# CITY OF BELOIT

## REPORT TO THE BELOIT LANDMARKS COMMISSION

**File Number:** COA-2014-46

**Location:** 820 Chapin Street

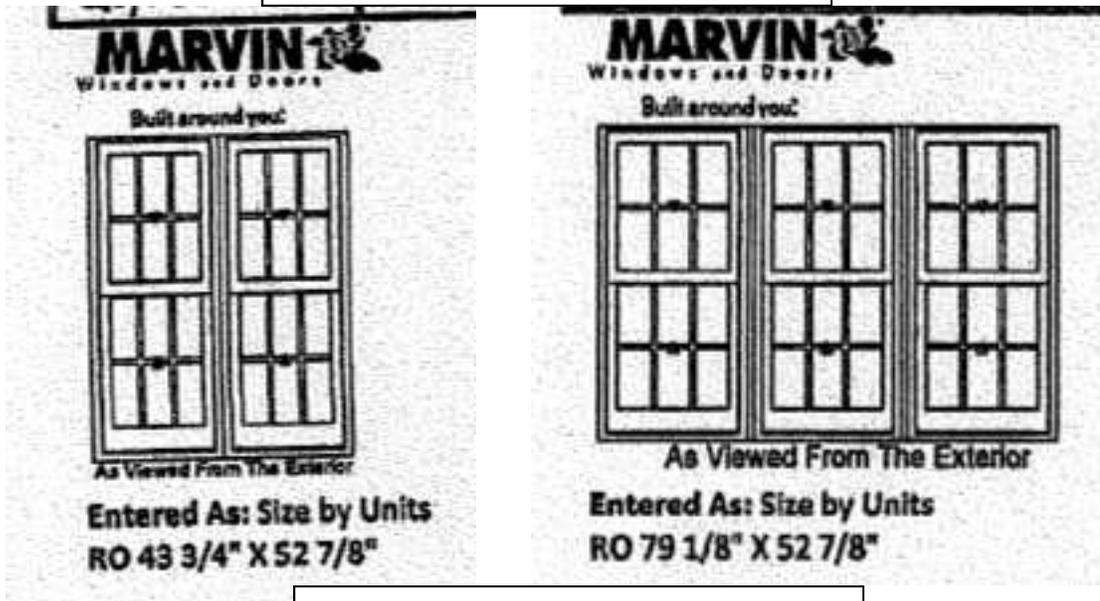
- The existing windows on the rear porch of the subject property are rotted and deteriorated wood windows.
  - The applicant is proposing new vinyl, double-hung windows for the rear porch of the subject property. Exterior grilles will be added in either a 6-over-6 or 6-over-1 design. Aluminum wrap will be used on the exterior. The windows will be white. These windows are not visible from the roadway.

- The windows throughout the home are either 6-over-1 or 4-over-1 while the existing rear porch windows are full grid style in varying sizes. Because of this, Staff is comfortable with either design and is recommending leaving the selection up to the applicant.

- (1) Proportions of Windows and Doors: The proposed windows are proportional to the size and scale of the house and the existing window openings.
    - (2) Architectural Details: The proposed window material is not compatible with the original architectural style and character of this historic house, but replacement wood windows at this size and design is cost prohibitive.

The Planning & Building Services Division recommends **approval** of a COA to install new rear porch windows and associated trim work at the property located at 820 Chapin Street, based on the standards and criteria contained in the Historic Preservation Ordinance and subject to the following conditions:

1. The applicant shall obtain a Building Permit before beginning any work.
  2. The rear porch replacement windows shall be either a 6-over-6 or 6-over-1 design.
  3. All work shall be completed by July 1, 2015.
  4. Any changes or additions to this COA must be reviewed and approved by staff prior to the start of any work. Work done without prior approval will be subject to the issuance of correction orders or citations. The completion date above does not extend any other time limits, such as those imposed by an order from an Inspection Official.
-
